## DEVELOPMENT SERVICES COUNCIL REPORT

File No: DP 21-36

Subject: **DP 21-36 – Development Permit with Variances (2237 Shannon Lake Road**

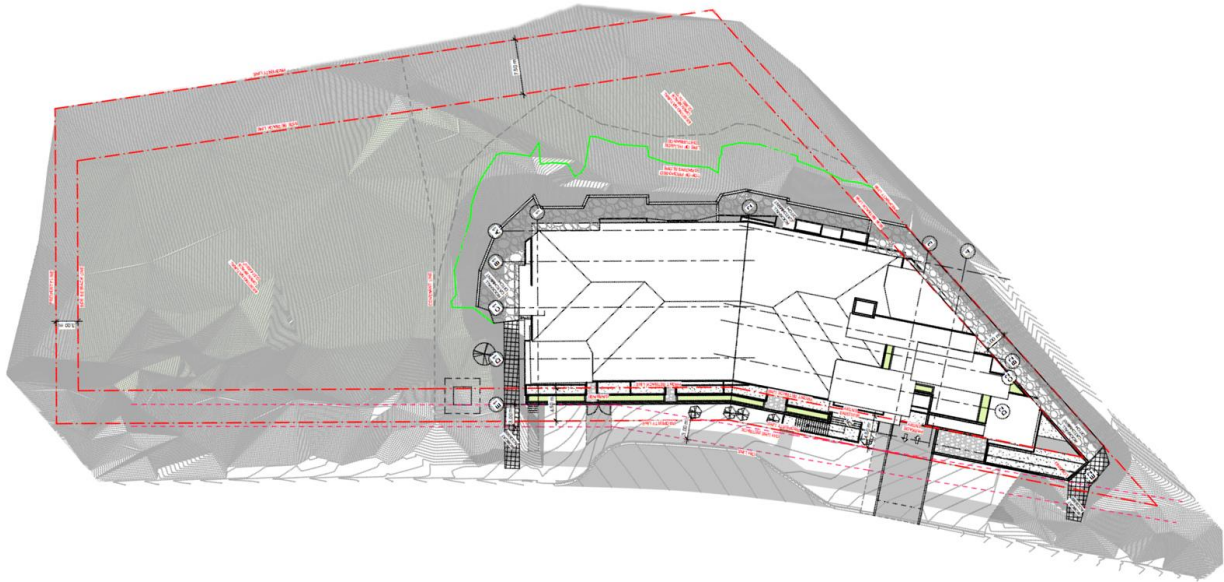
- Environmental features such as mature stands or trees and existing native vegetation is protected (Guidelines s.4.2.5.7. and s.4.2.5.8.)
- Site development does not dramatically change the natural topography of the site, and grading requirements are resolved within the property boundary. Cut and fill will be minimized and blended to the existing terrain (Guideline 4.2.5.10)

Figure 1 – Site Plan showing development concentrated on the site to protect the remaining trees and native vegetation. An existing geotechnical covenant exists on the left (north) side of the property, and a further covenant will be required on the remainder of the site not proposed to be developed. Changes to the grade are located behind the proposed building and any grading requirements (rock cuts, retaining walls etc.) will be located within the property boundaries.

Figure 3 – Cross section of a portion of the building showing one of the proposed rock cuts (red line), temporary rock cut (yellow line) and existing ground (green dashed line) at the rear. Rock cut would require mechanical stabilization (wire mesh) as recommended in the geotechnical report.

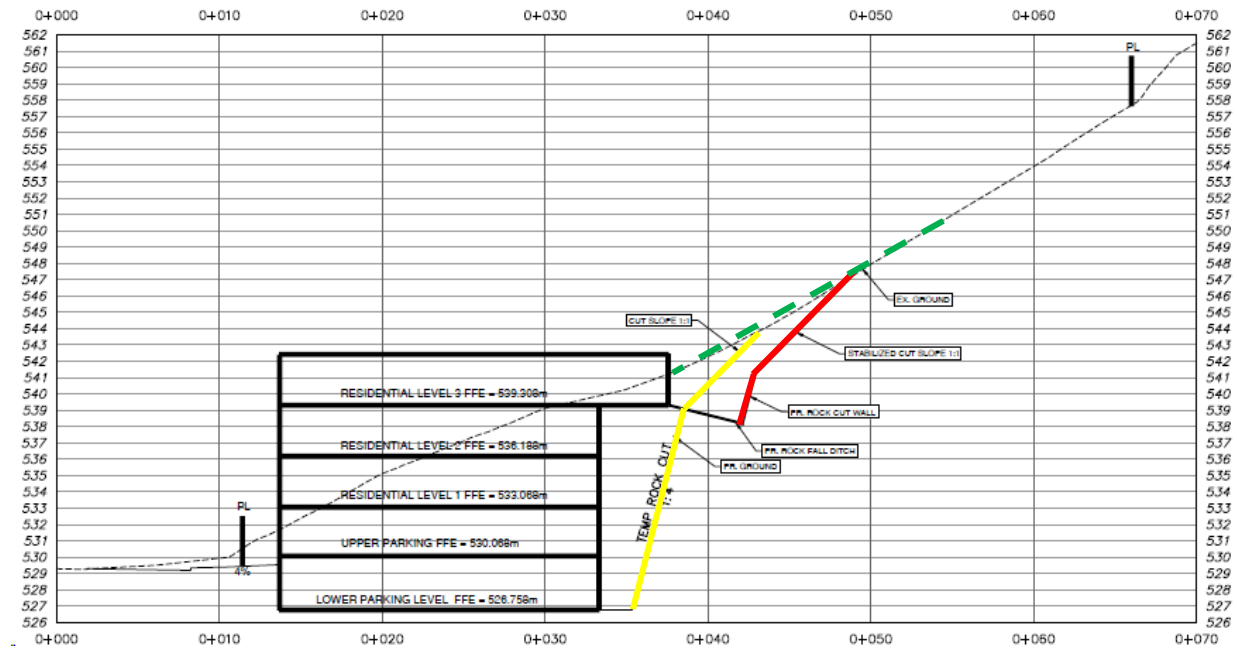
- A geotechnical report prepared by a professional engineer has been provided for this development. The geotechnical report states “from a geotechnical perspective, the proposed development site is safe for intended use, provided that our recommendations and mitigation measures are followed during the design and construction of the project.” The geotechnical report includes recommendations for the proposed modifications to the site including mechanical stabilization of the rock face where necessary. These stabilization techniques (wire mesh) will be screened from Shannon Lake Road as they are located behind the building (See Figure 3) (Guideline 5); and

Figure 5 – Three proposed retaining walls located behind the proposed building.

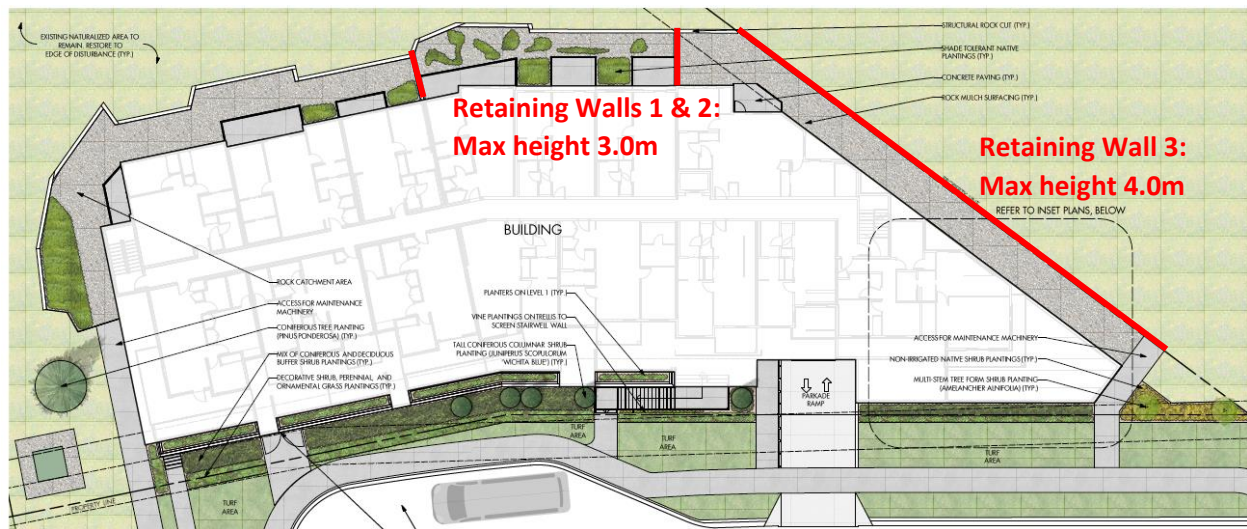
The development proposes a maximum retaining wall height of 4.0 m instead of 2.5 m. The intent of the retaining wall height regulation is to limit the visibility of large walls in developments and the manipulation of the natural topography of the site. The development includes three retaining walls. Two walls with a max height of 3.0m and one wall with a max height of 4.0m. The walls are located behind the proposed building and are required to develop the site as per the applicant's rationale in Attachment 2.

This variance is supported as the retaining walls are subtly integrated into the proposed development as per DP guidelines and assist in meeting other DP guidelines such as providing a rock catchment ditch to keep the development outside of potentially hazardous areas.

Figure 6 – Top: Front elevation; Middle Left: Side elevation north; Middle Right: Side elevation south; Bottom: Rear elevation.

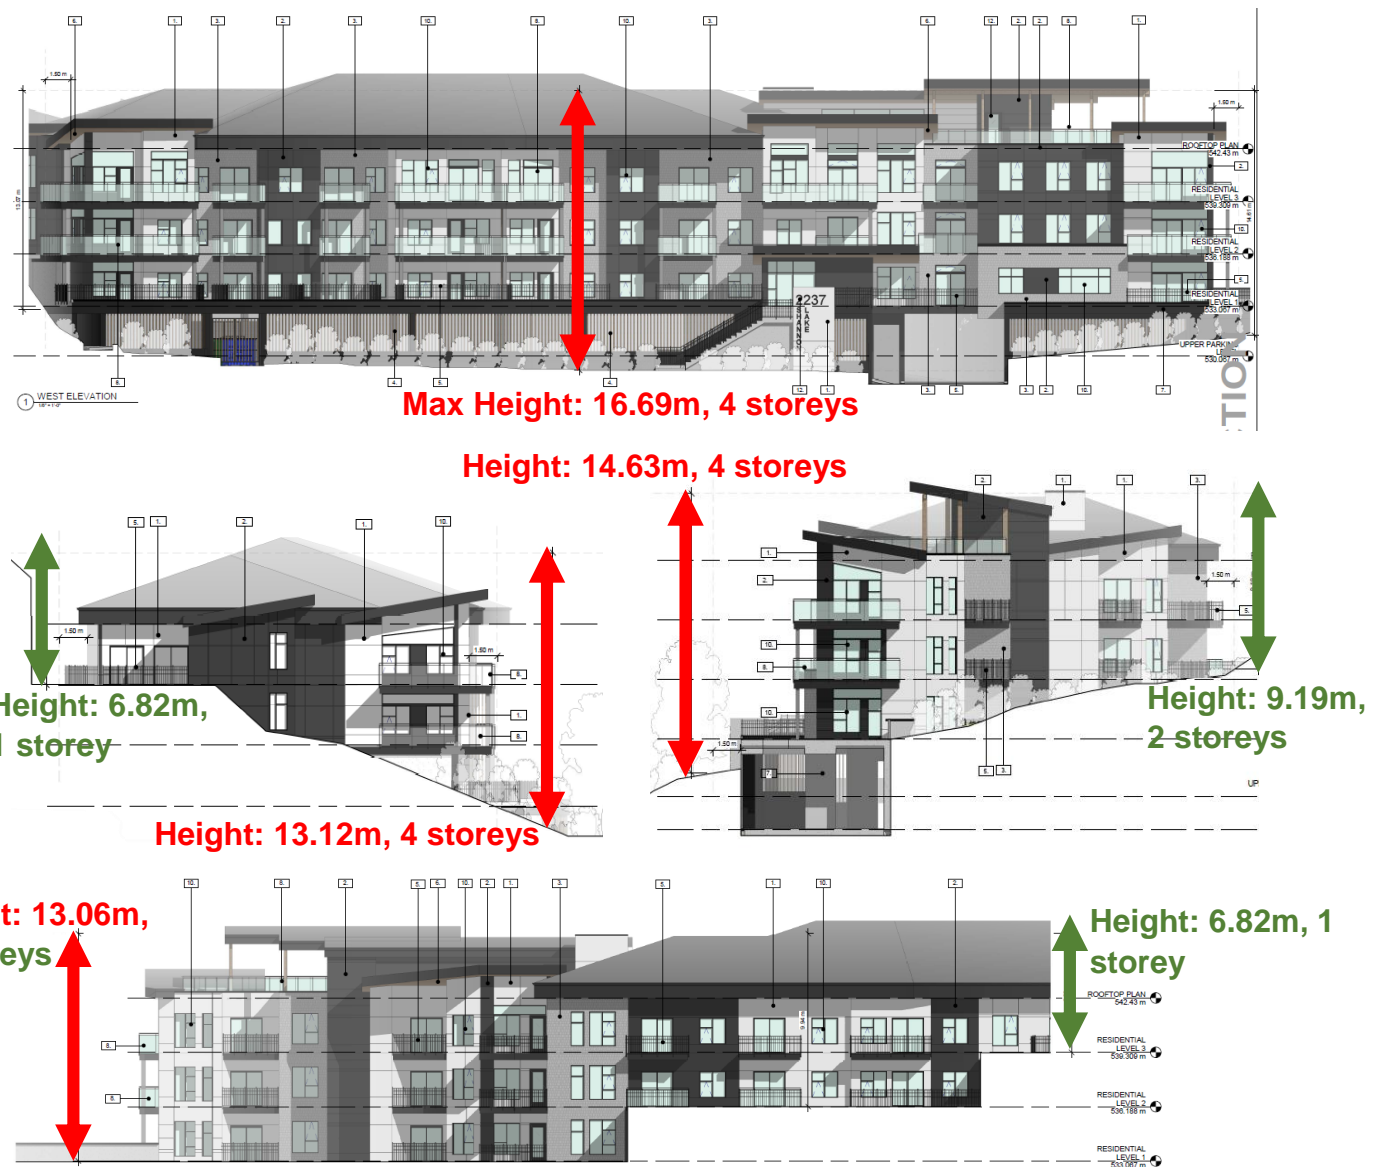
The development proposes a maximum building height of 16.69m to four storeys instead of 10.0m to a maximum of 3 storeys. The maximum building height is focused on the front of the building with the height decreasing at the sides of the building and being within the bylaw requirements at the rear. The applicant has provided a rationale for this variance (Attachment 2).

The variance is supported as the increased height and number of stories is caused by the partially exposed parkade. Further undergrounding the parkade would result in additional site modification. The parkade has been screened using decorative wood slats and landscaping to meet DP guidelines, and height decreases towards the interior of the site. It is noted that the OCP designation for this property permits multi-unit housing up to 4 storeys. Currently, 4 storeys in the Zoning Bylaw means up to 15.0m in height. Staff are reviewing the Zoning Bylaw given adoption of the new OCP, and this regulation may change.

Figure 7 – Proposed front setback variance, largely triggered by stairs to apartment lobby.

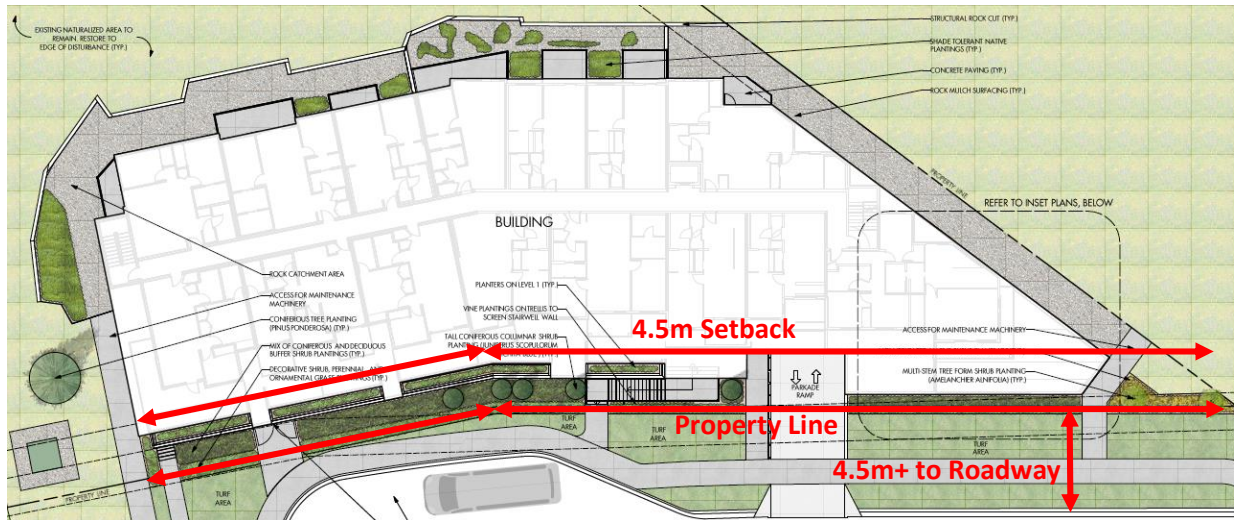
The development proposes a minimum front setback of 0.0m instead of 4.5m. The setback variance to 0.0m is triggered by the proposed stairs to the main entrance. The

partially exposed parkade is setback 2.29m except it is approx. 1.0m on the far right (south) and the rest of the building is setback further (See Figure 7). The applicant has provided a rationale for this variance (Attachment 2).

This variance is supported given the sensitive terrestrial and hillside features on the site. By locating the building as close as possible to the property line, as much as possible of the existing vegetation can be maintained. This reduced setback also limits encroachment into the steeper areas of the site and helps keep development outside of areas with potentially hazardous conditions. Despite the setback reduction the development also maintains more than a 4.5m setback from the travelled portion of Shannon Lake Road.
